IN REPLY REFER TO:  
NCPC File No. ZC #08-06A

RE: NCPC Comments on Proposed Text Amendments to DC Zoning Regulations

## **APPENDIX A**

### **Visual Modeling Study for North Capitol Street**

## North Capitol Street Visual Study

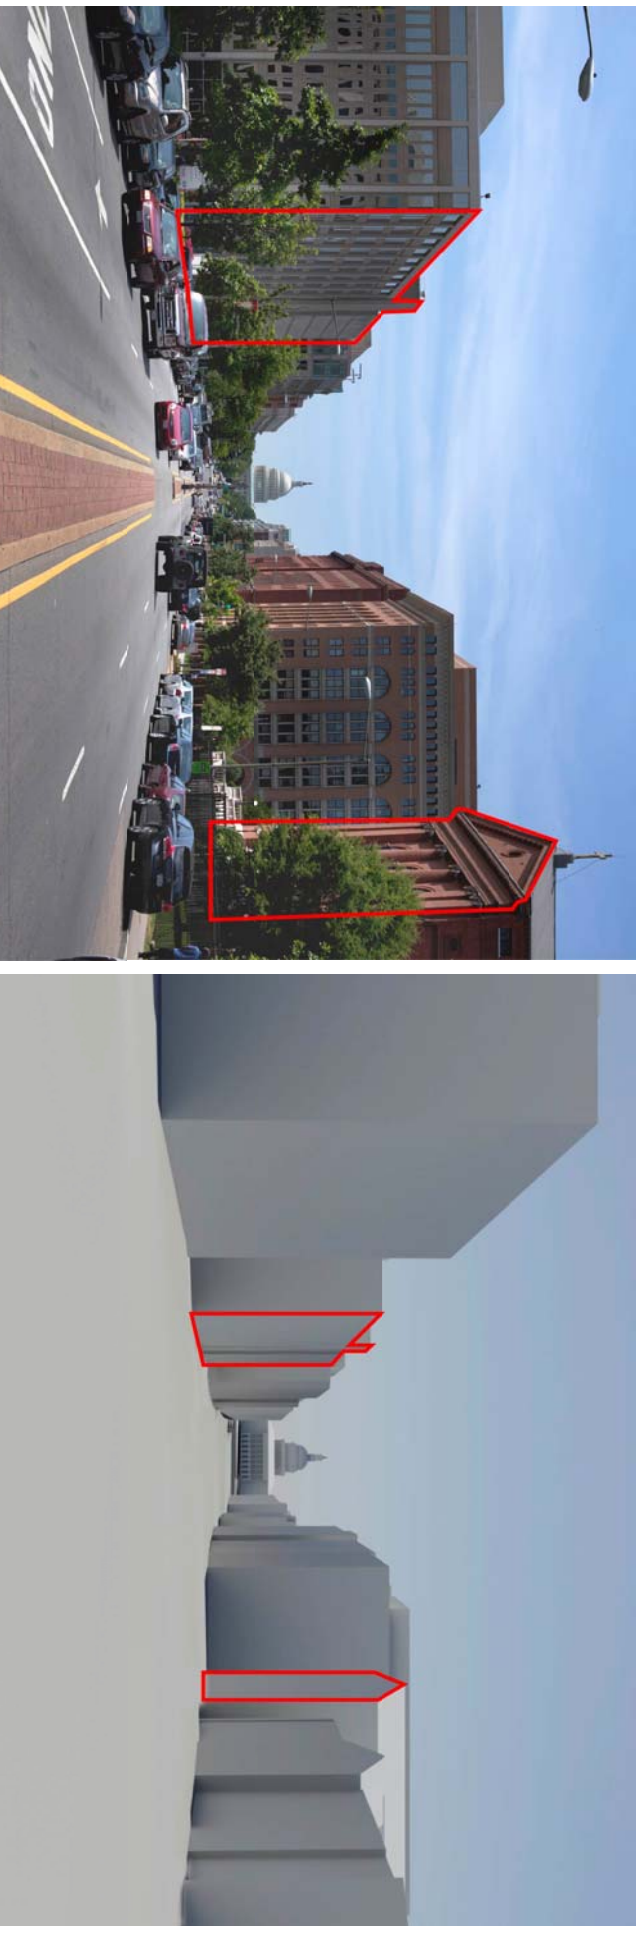
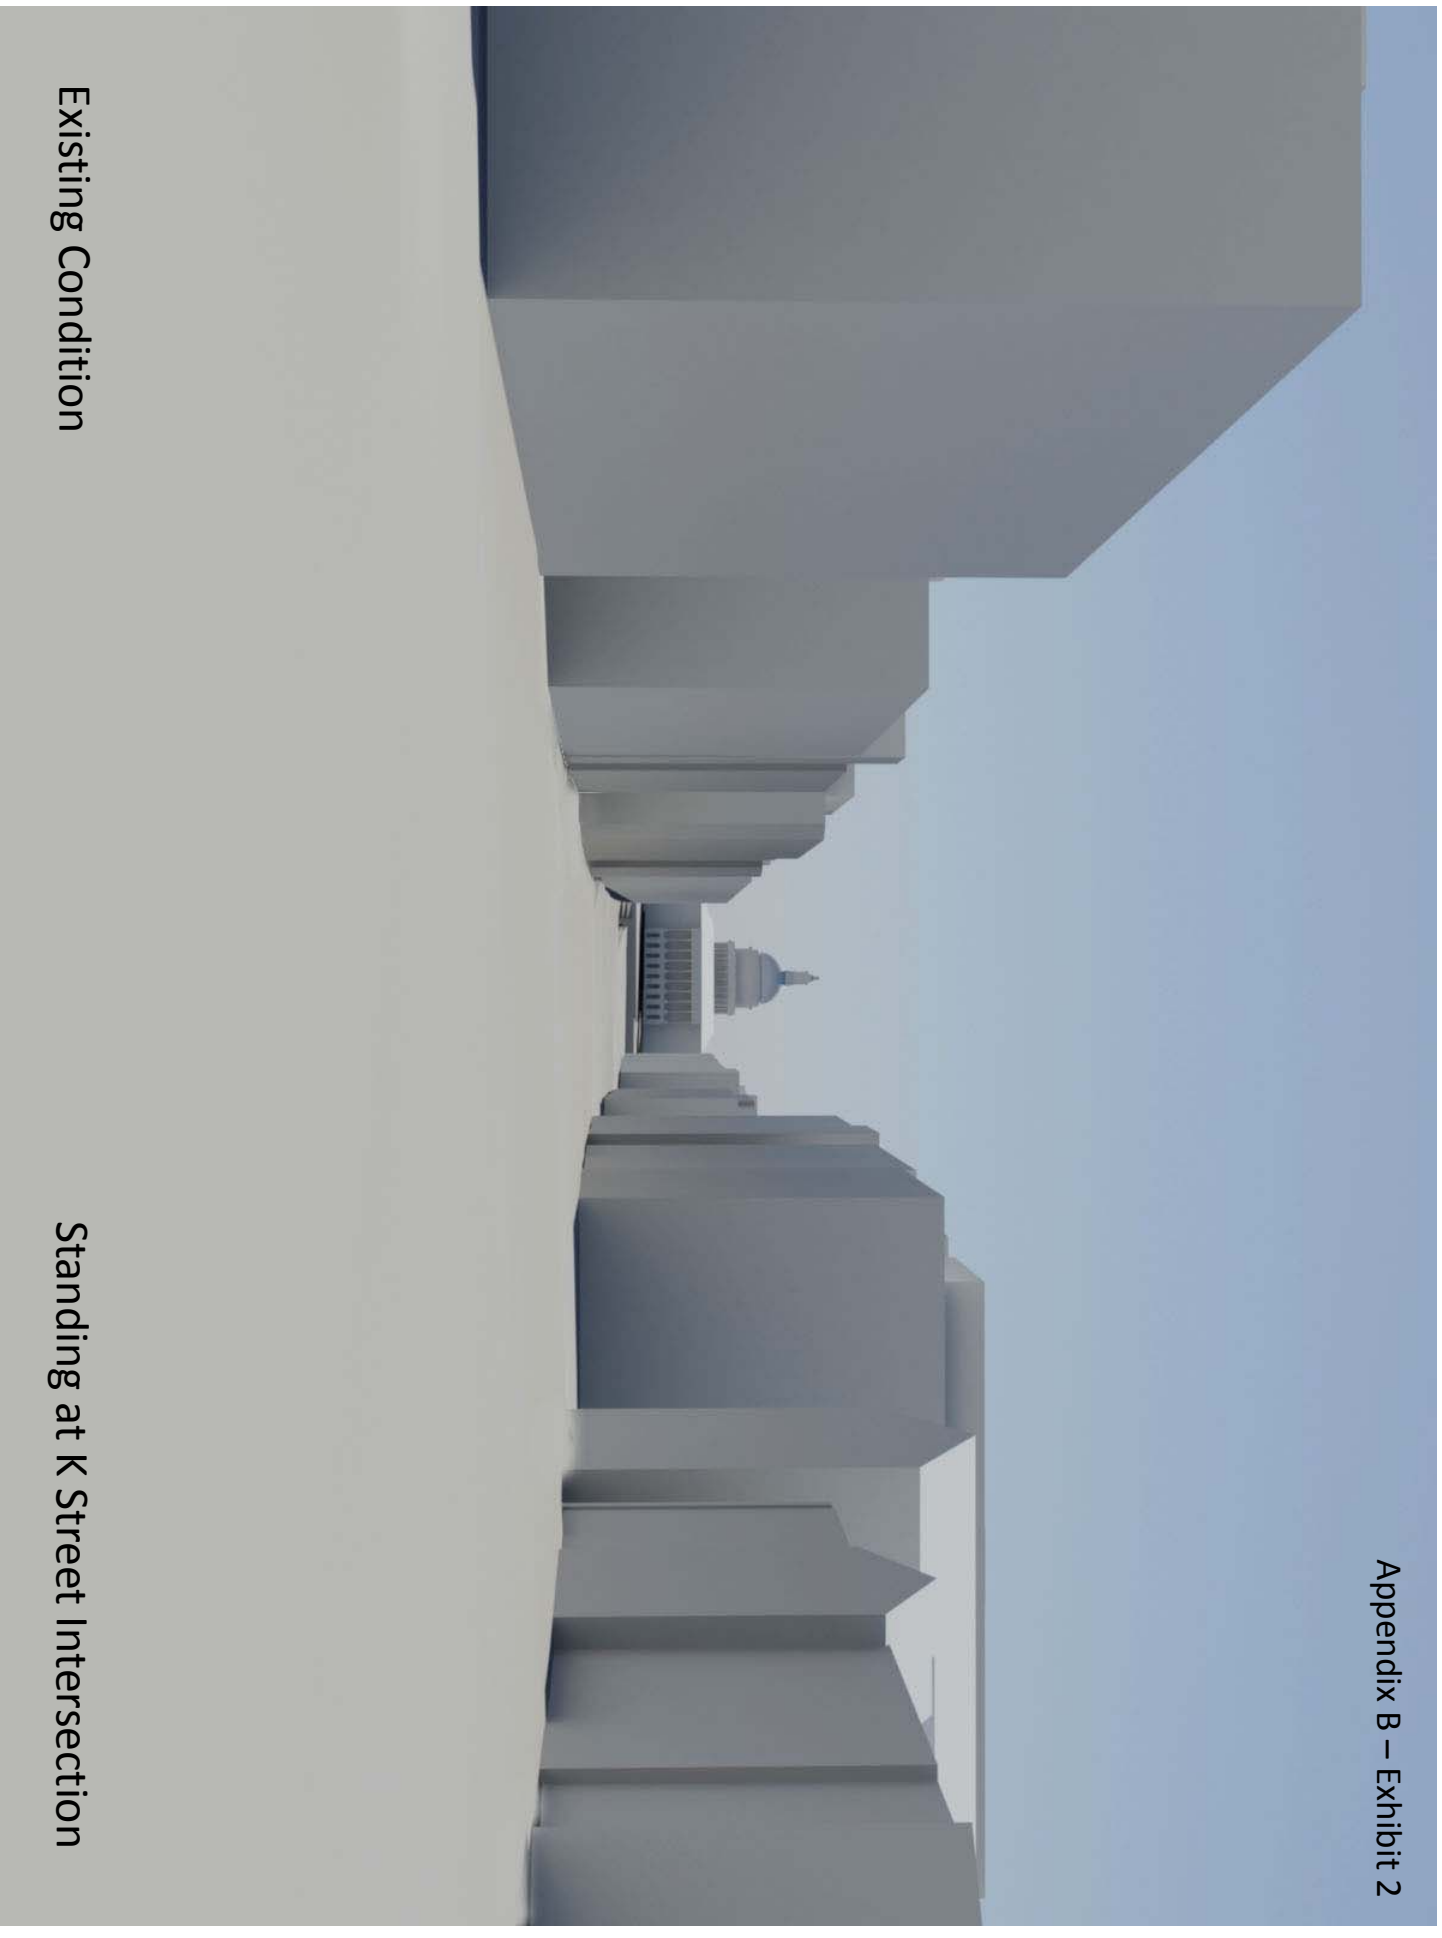
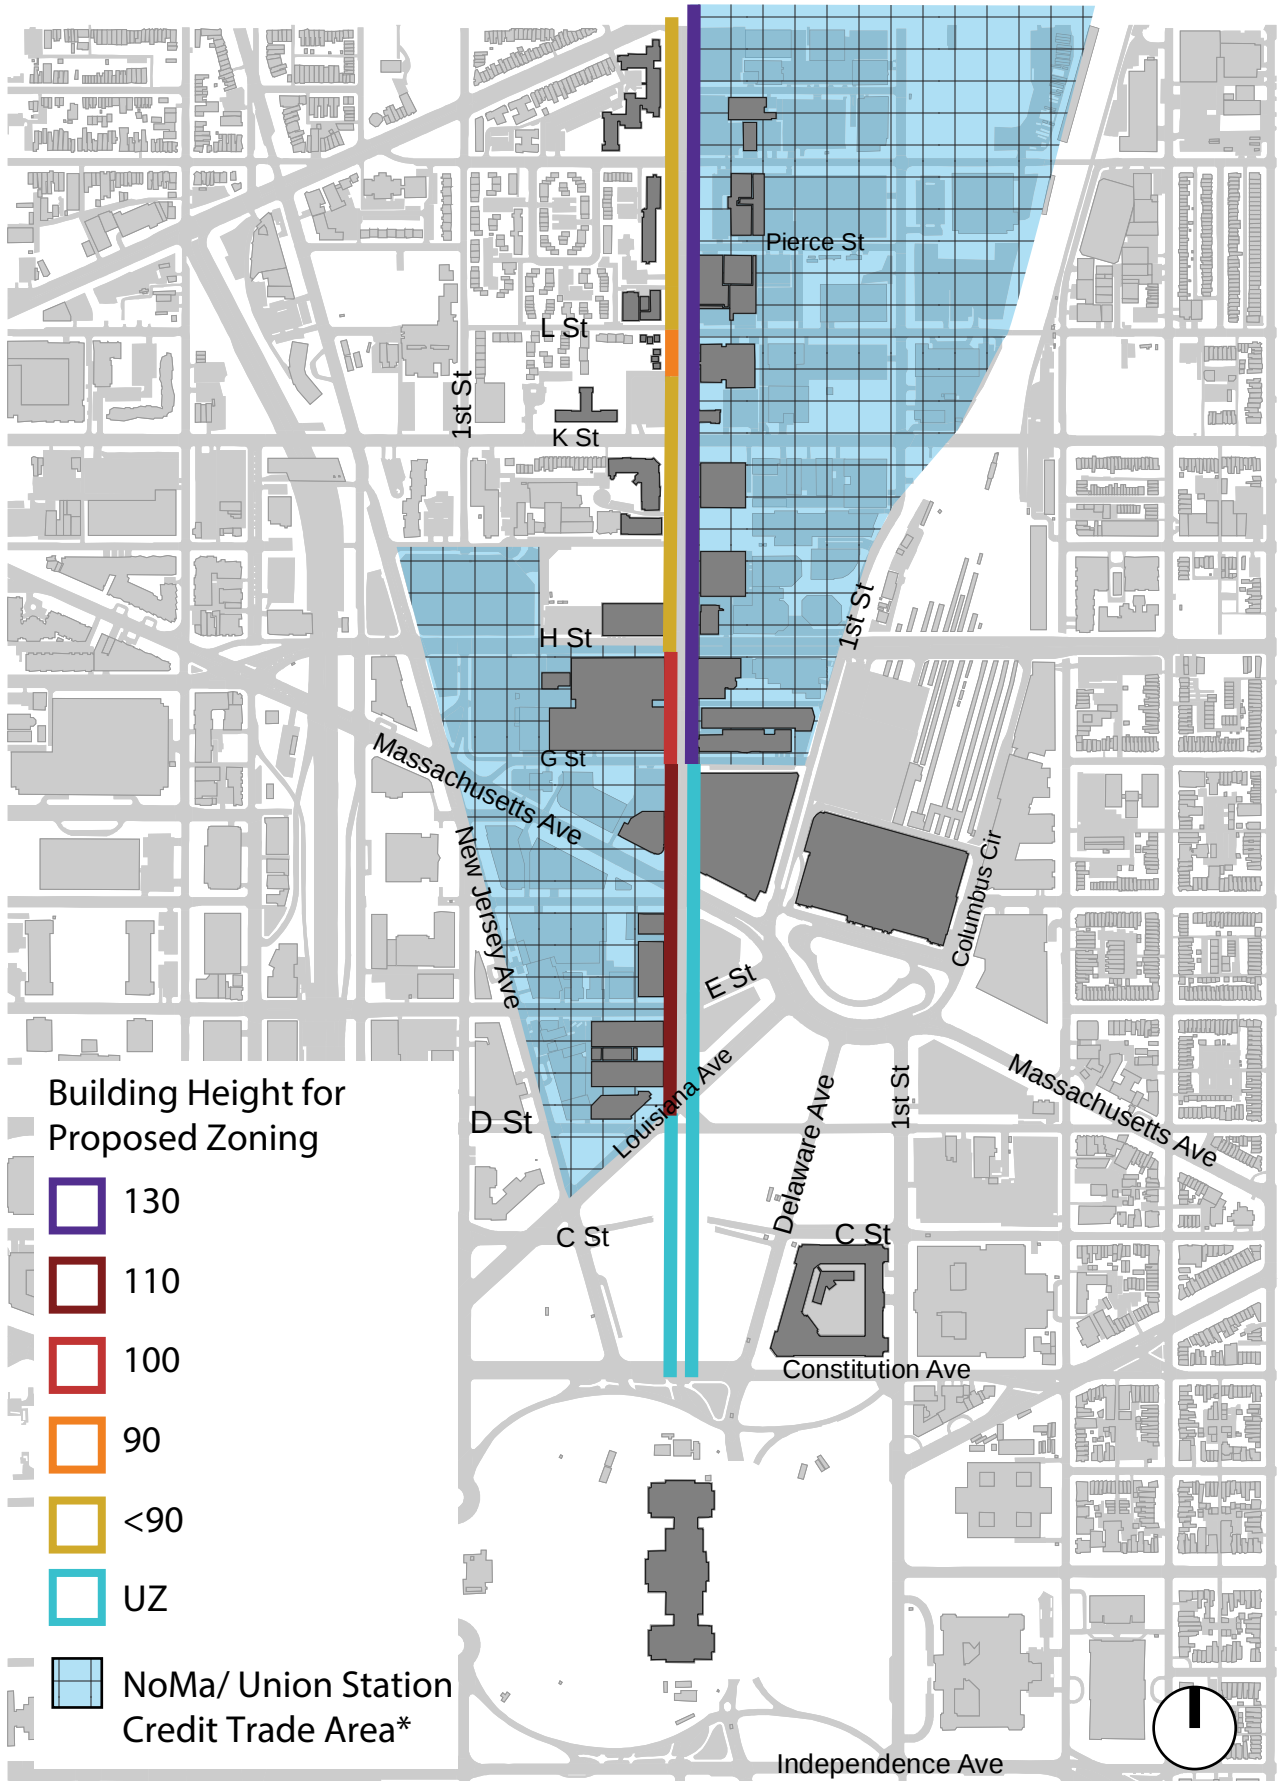
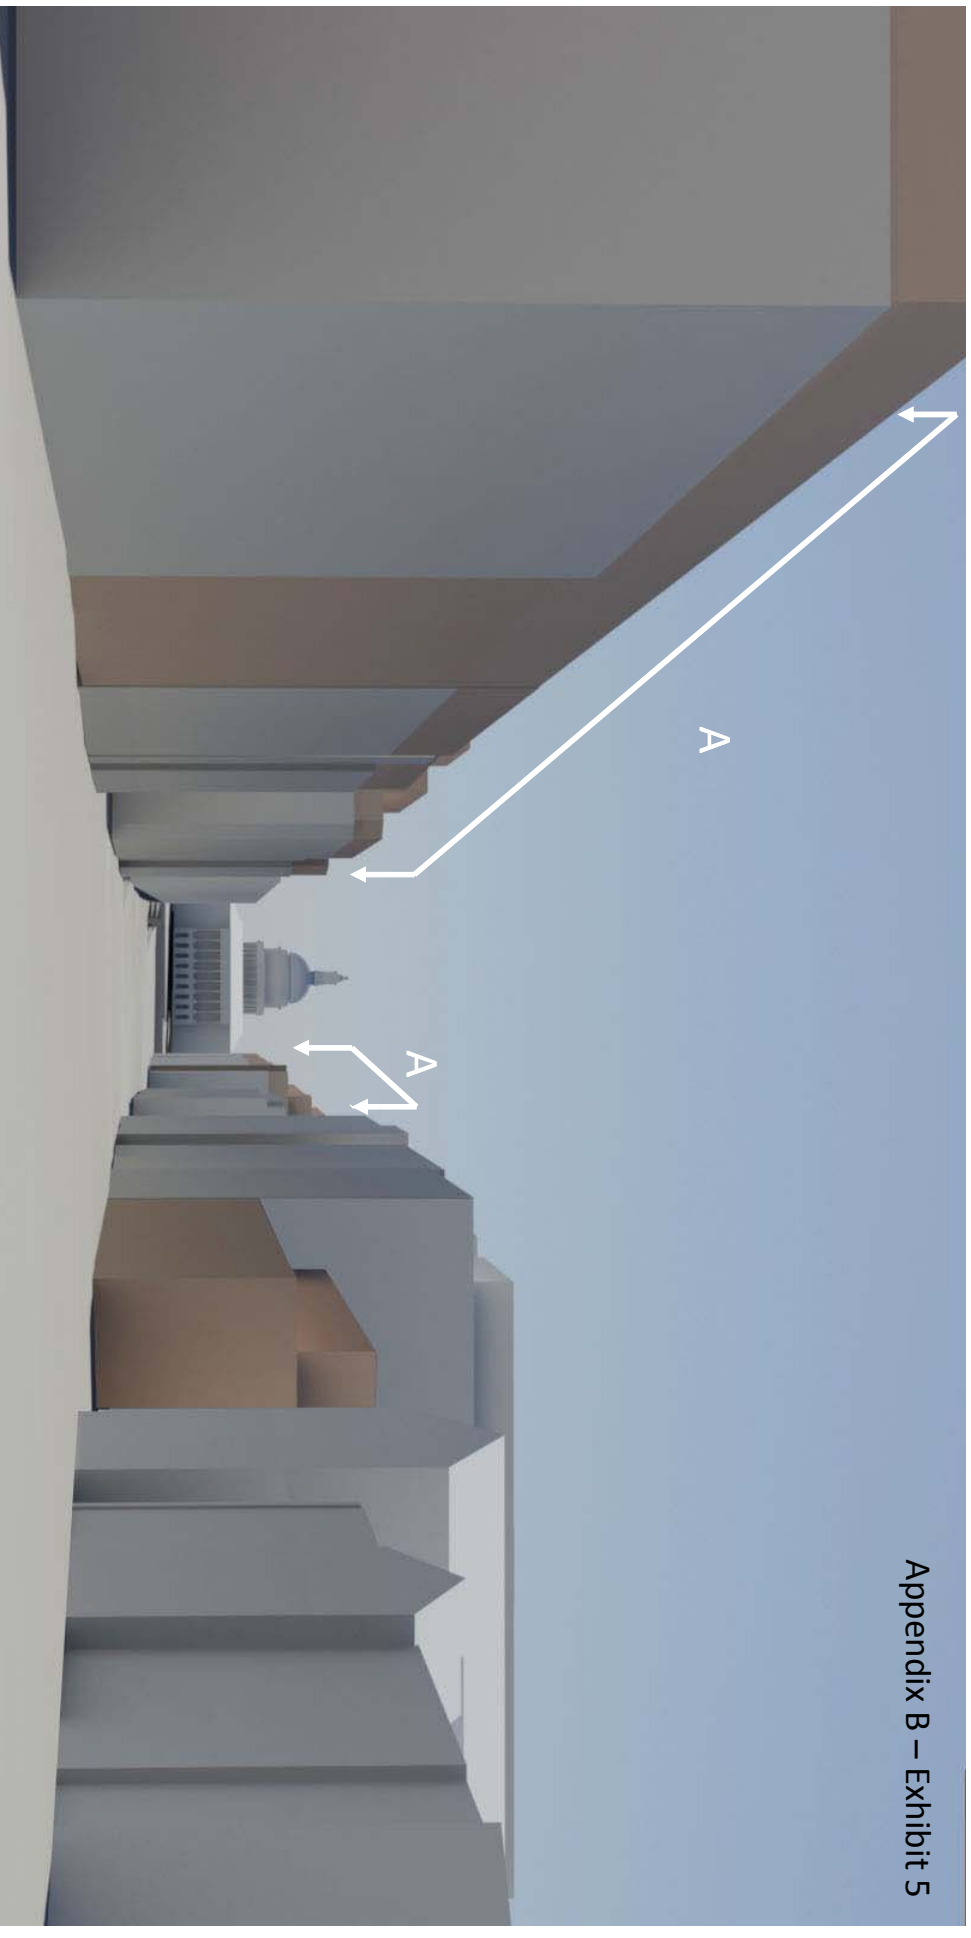
from K Street, an area that defines the composition of buildings and open spaces immediately to the north of the U.S. Capitol. *As proposed in the zoning update, there are four separate zones with different MOR heights that bisect North Capitol within this five-block area: D-5-B-1, D-4-B-1, D-3-B-1, and other areas not included in the Downtown Zone on the west side of the street north of G Street.* There are also several prominent federal properties and lands within this portion of North Capitol Street. The visual study considered strategies to create a cohesive building edge on these blocks and to ensure that the dome is not diminished by the proposed Matter of Right building heights.

The second visual study south of M Street illustrates the undefined edges along each of the blocks within the corridor, weakening the composition among buildings on either side of the street. This results in the impression that North Capitol is defined by the edges of the areas around it, rather than the preeminence of the dome and as a distinctive place unto itself. North Capitol Street should be developed as a distinct, cohesive corridor with urban design strategies that address these important transitions in density and land use, reinforce the quality of views to the Capitol, and promote the potential of this street as one of our city's most important gateways. Given the complexity of the land use conditions and urban design issues, NCPC staff does *not* make a recommendation for the blocks to the north of K Street. However, we welcome the opportunity to work with the Office of Planning through the Comprehensive Plan or more specific study, as appropriate, to consider urban design strategies for the entirety of North Capitol Street within the L'Enfant City.

Note: This conceptual visual study illustrates the undefined edges and difficult transitions between densities on either side of this corridor under proposed zoning. This potential building composition results in the impression that North Capitol is defined by the edges of the zones around it, rather than the preeminence of the dome and as a distinctive corridor. Given the complexity of the land use conditions and urban design issues, NCP staff does *not* make a recommendation for the blocks to the north of K Street, including the intersection shown in this illustration. However, we recommend that the urban design framework for North Capitol Street up to Florida Avenue be addressed through the Comprehensive Plan or more specific study, as appropriate. Future study should consider urban design strategies that address these important transitions in density and land use, reinforce the quality of views to the Capitol, and promote the potential of this street as one of our city's most important gateways.

- **On lands subject to zoning and not subject to any other height restrictions<sup>2</sup>: require a 1:1 step back at 110' feet within the Proposed D-5-B-1 Zone from Louisiana Avenue to K Street, NW. This step-back will ensure that the Capitol dome is not diminished by the proposed Matter of Right building heights and will also encourage a consistent cornice line in the blocks immediately adjacent to the Capitol.**

- **NCPC staff seeks to clarify the status of the D-3-B-1 Zone, which has a proposed MOR height of 110 feet. However, this is also identified as a receiving zone area. If, as a receiving zone, the maximum height allowed is 130 feet, staff recommends a 1:1 step-back at 110 feet. See Appendix B for an illustration.**

110' + additional 1:1 height step back  
for 20' + penthouse

A. Proposes a base height of 110' feet with a 1:1 height step back for any additional height for all areas where 130 feet may be achieved as a matter of right or within credit trading areas.
